8/16/21

RE: 23-DR-2021  
AC Scottsdale AKA Kimsey  
986U0 (Key Code)

The Planning & Development Services Division has completed the review of the above referenced development application submitted on 6/29/21. The following 1<sup>st</sup> Review Comments represent the review performed by our team and is intended to provide you with guidance for compliance with city codes, policies, and guidelines related to this application.

FIGURE 5

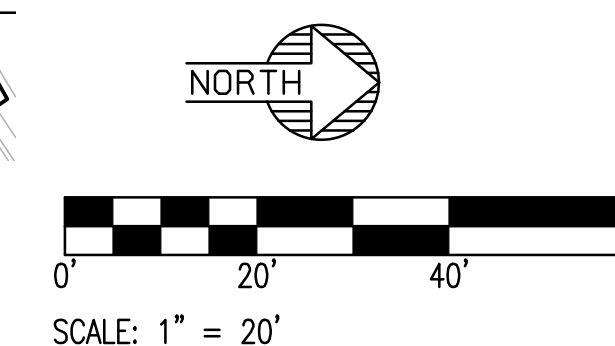
No, not access  
easement. PUE. IS  
this an old figure?  
Subsequent  
figures show this is  
as a PUE.
